ADDENDUM NO. 2

February 9, 2026

Southport High School Addition & Renovation Phase 1 (Activity Center Addition & Wrestling/Center Plant Renovation)
971 E. Banta Road
Indianapolis, IN 46227

FRAMING
SCHEDULES,
SECTIONS, &
DETAILS

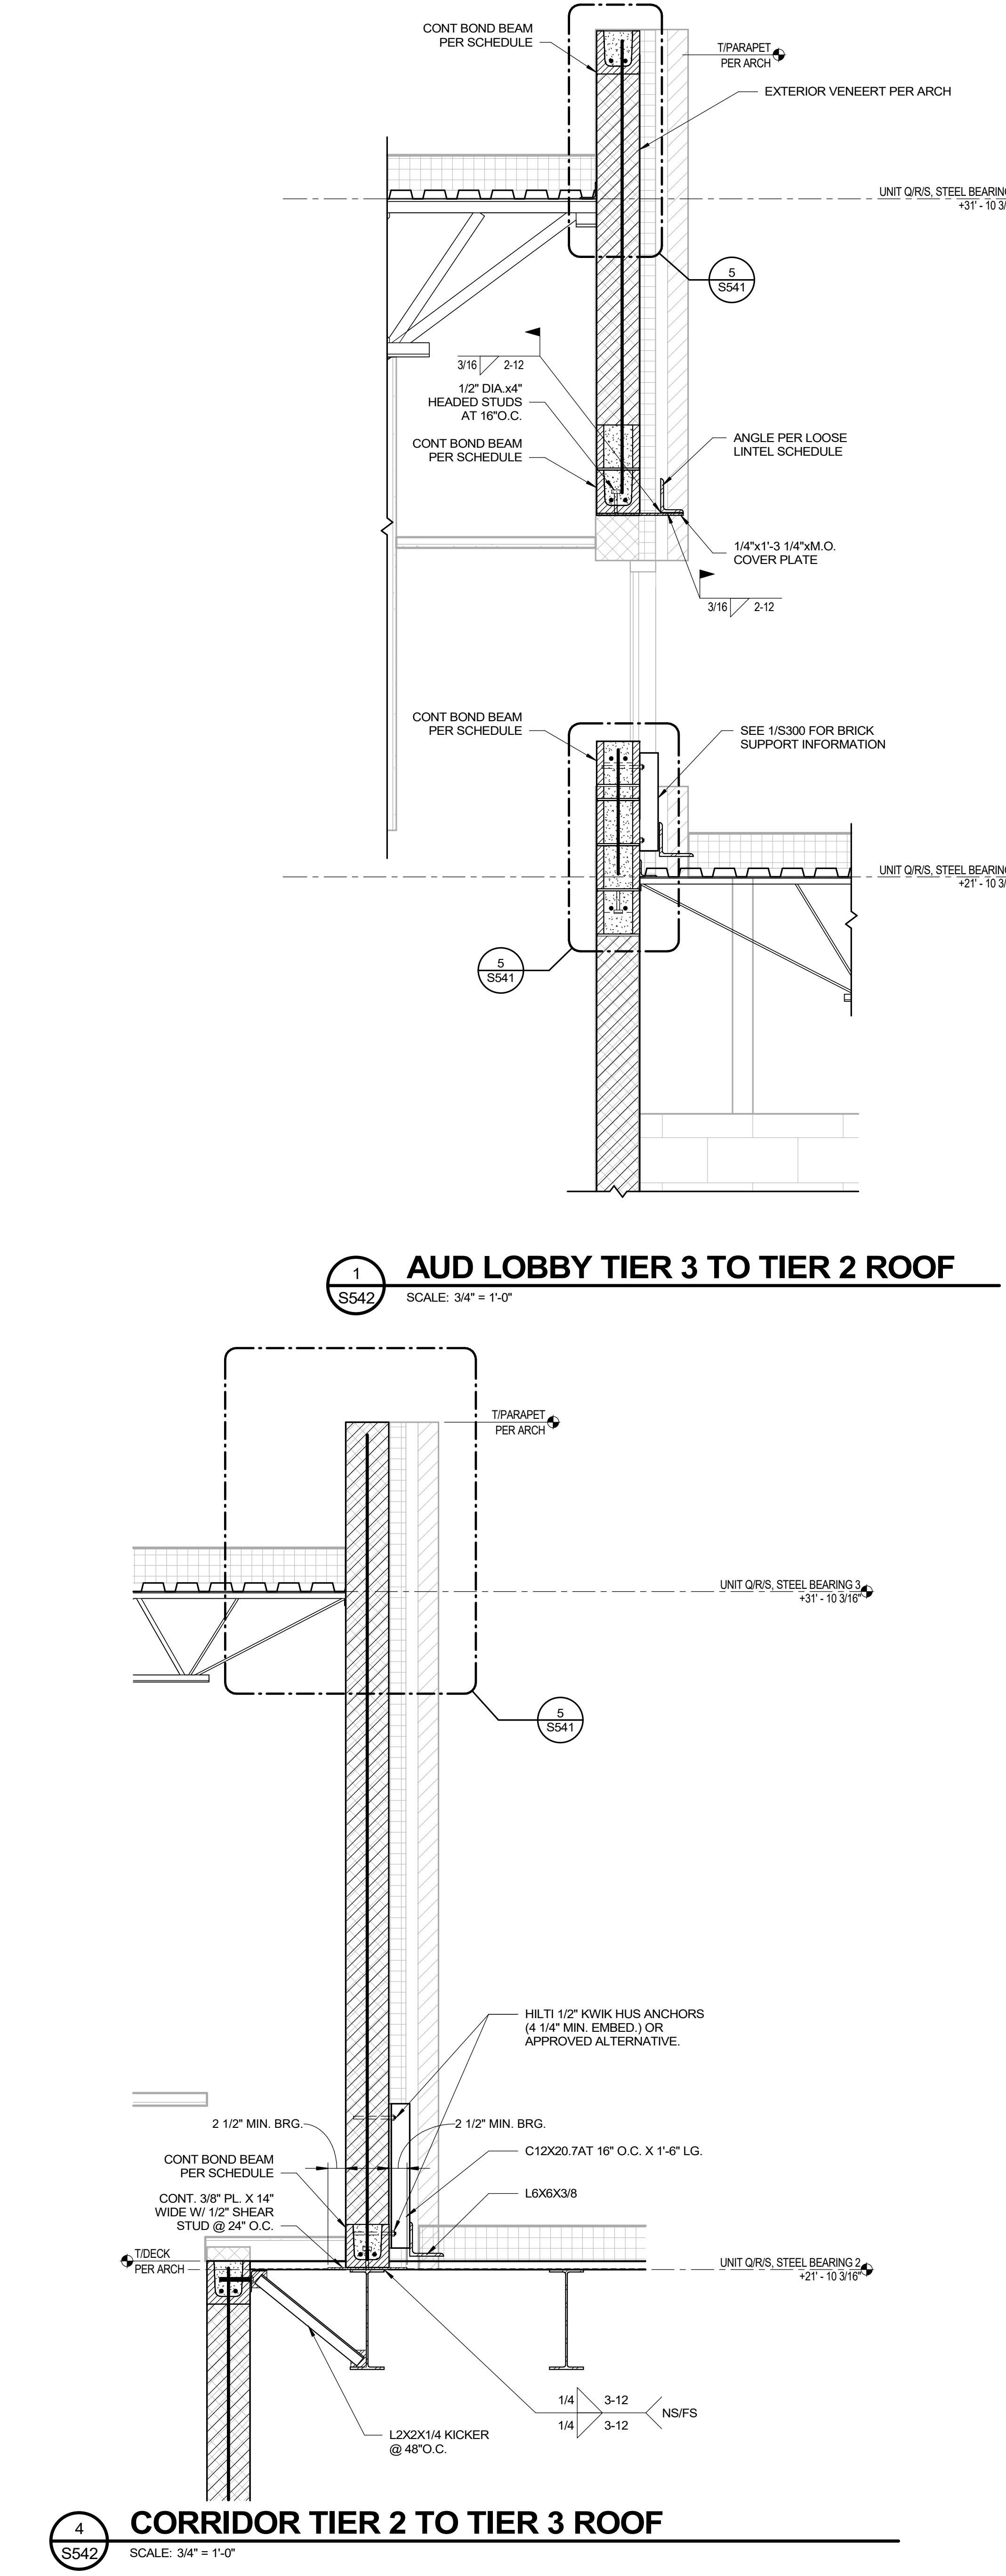
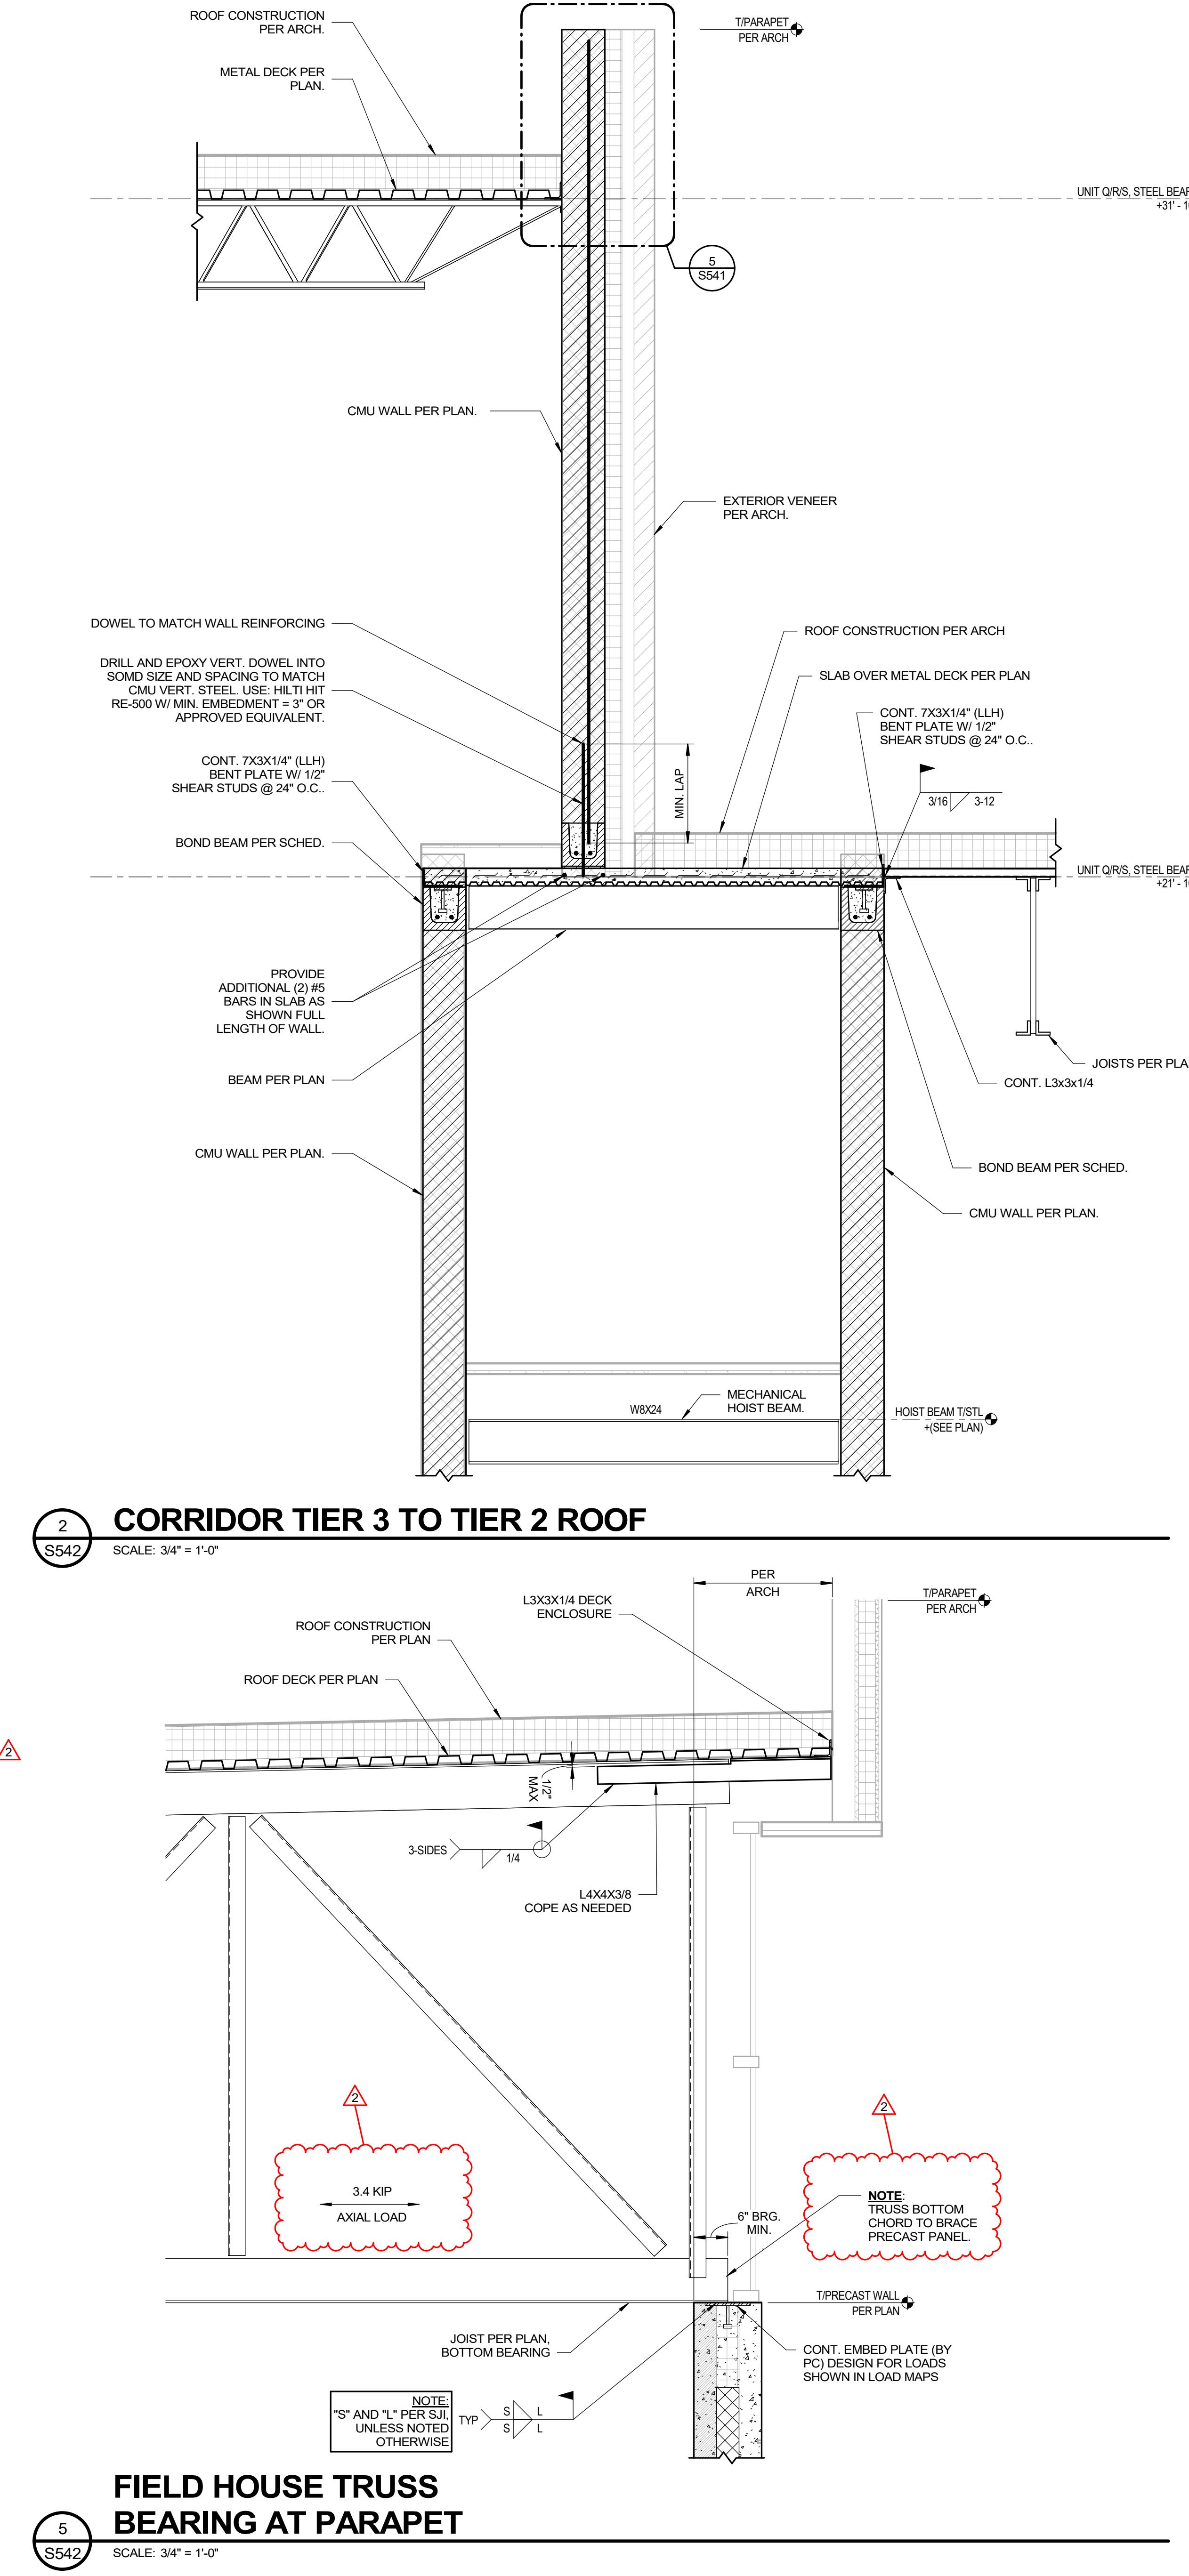
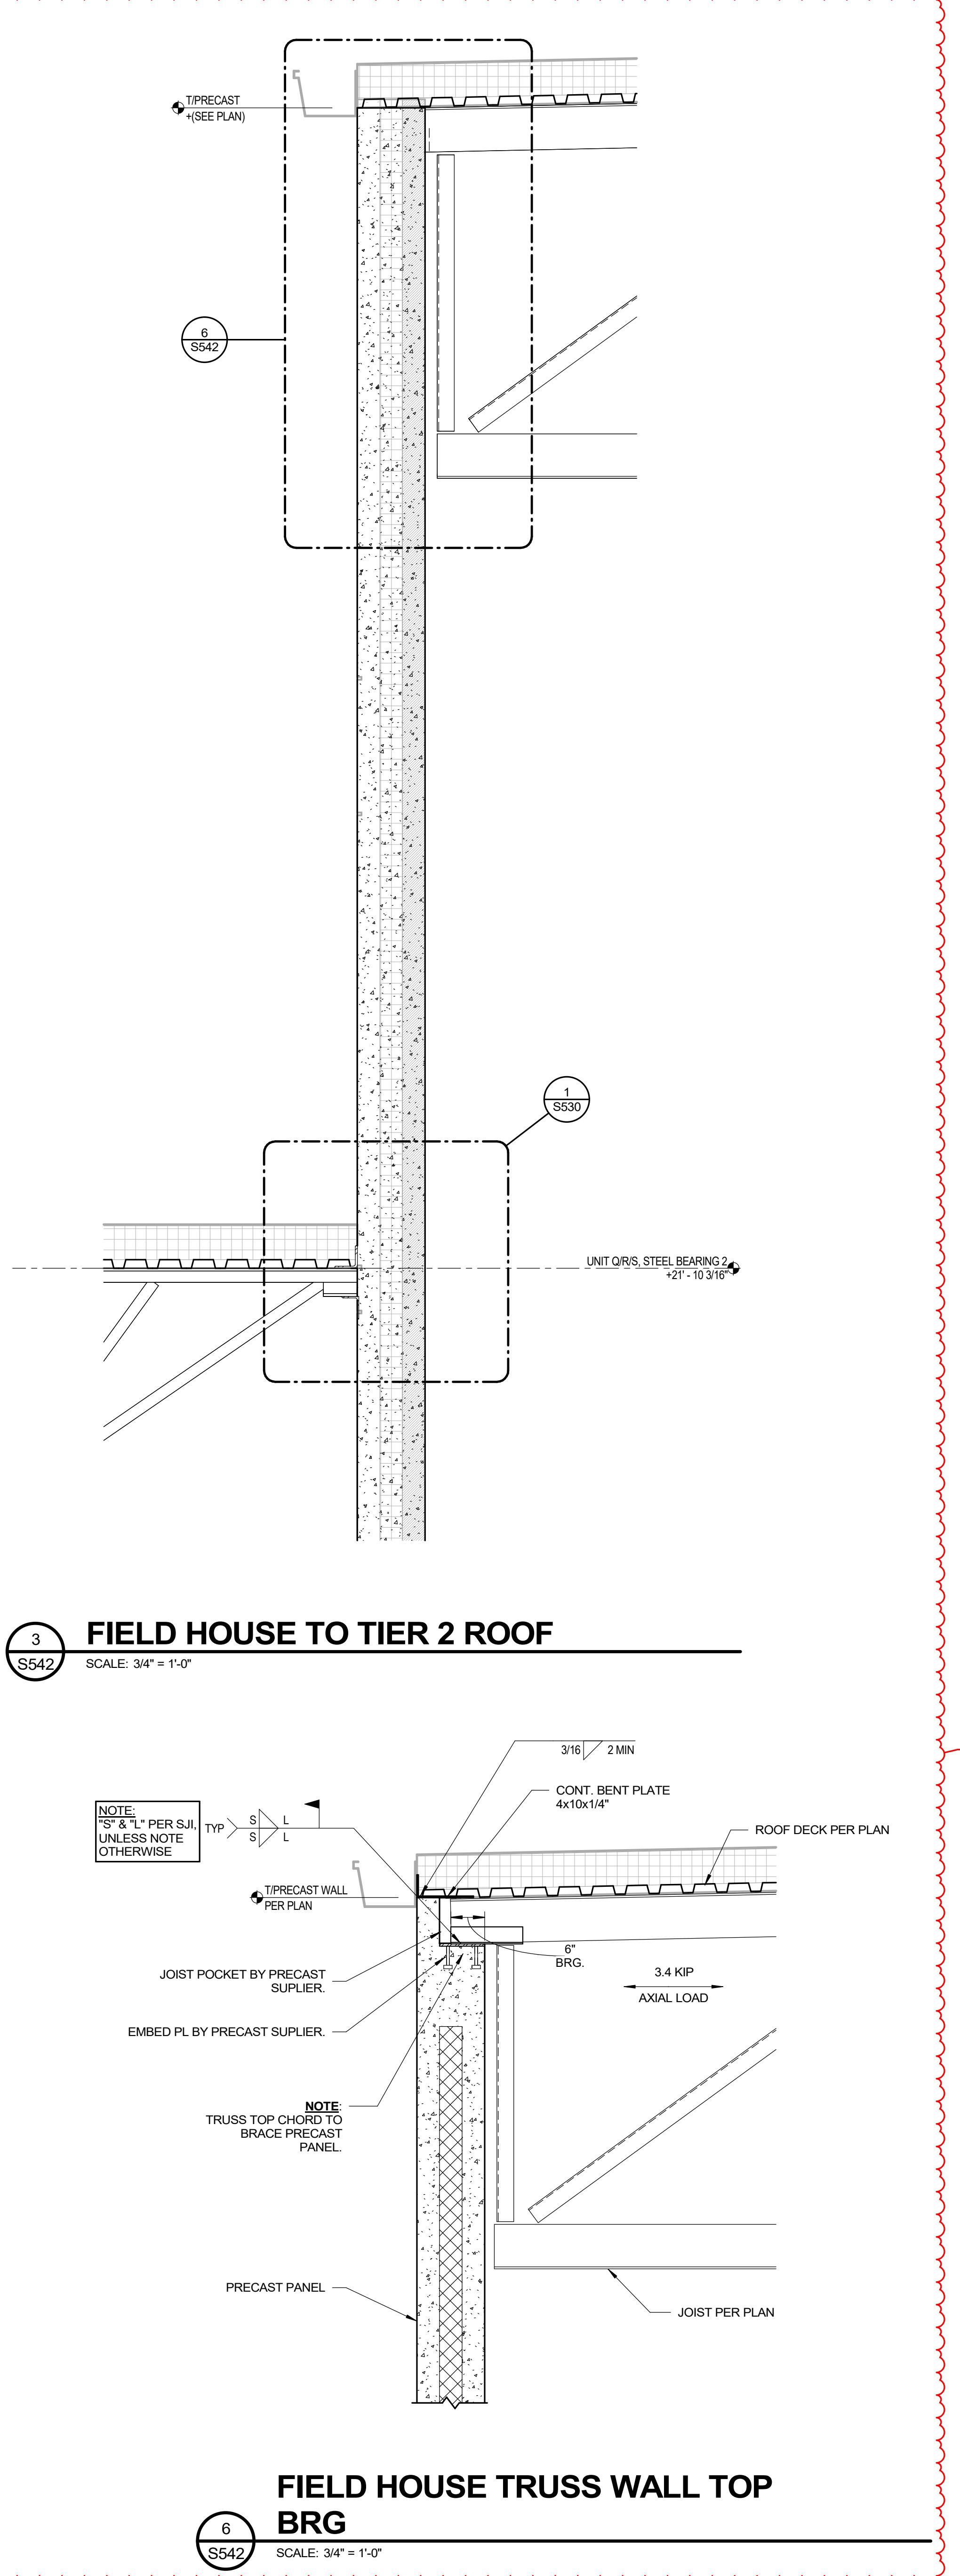
Change: Updated details, 3, 5, & 6.

- Changed roof truss bearing from bottom bearing to top bearing to 3/S524.
- Provided axial loading to roof truss to 5/S524.
- Changed roof truss bearing from bottom bearing to top bearing and added axial loading to the roof truss to 6/S524.
- Added thickened slab.
